JOAN E. BAXTER SUBDIVISION

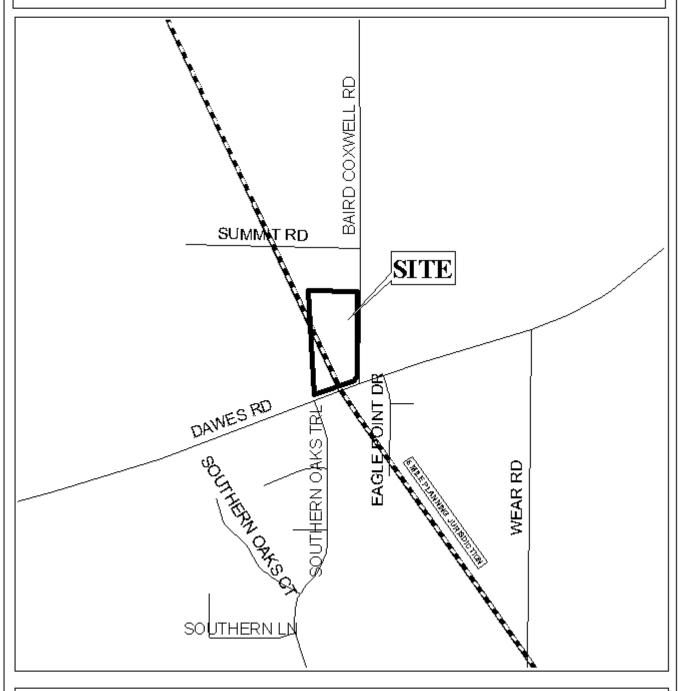
The site fronts Dawes Road, a planned major street, and the existing right-of-way is shown as 80 feet. The Major Street Plan requires a 100-foot right-of-way, therefore, the provision of a 75-foot setback (which includes the required minimum building setback of 25-feet) from the centerline of Dawes Road to provide for the right-of-way of the planned major street, should be provided. Additionally, as a means of access management, a note should be placed on the final plat stating that Lots 1 and 2 are limited to one curb cut each to Dawes Road, with the location, size, and design to be approved by County Engineering. Furthermore, with Lot 2 being a corner lot, the dedication of a 25' radius should be required.

As illustrated on the Vicinity Map, Baird Coxwell Road is dirt and access for commercial development should be denied until it is paved.

This site is located in the County, thus a note should be placed on the final plat stating that any lots which are developed commercially and adjoin residentially developed property must provide a buffer, in compliance with Section V.A.7. of the Subdivision Regulations.

A 25-foot minimum building setback line along Baird Coxwell Road is not shown but would be required on the final plat.

The plat meets the minimum requirements of the Subdivision Regulations and is recommended for Tentative Approval subject to the following conditions: 1) the provision of a 75-foot setback (which includes the required minimum building setback of 25-feet) from the centerline of Dawes Road; 2) the placement of a note on the final plat stating that Lots 1 and 2 are limited to one curb cut each to Dawes Road, with the location, size, and design to be approved by County Engineering; 3) the placement of a note on the final plat stating that direct access to Baird Coxwell Road for commercial development is denied until it is paved; 4) the dedication of a 25-foot radius at the corner of Dawes Road and Baird Coxwell Road; 5) the placement of a note on the final plat stating that any lots which are developed commercially and adjoin residentially developed property must provide a buffer, in compliance with Section V.A.7. of the Subdivision Regulations; and 6) the placement of a 25-foot minimum setback line along Baird Coxwell Road on the final plat.
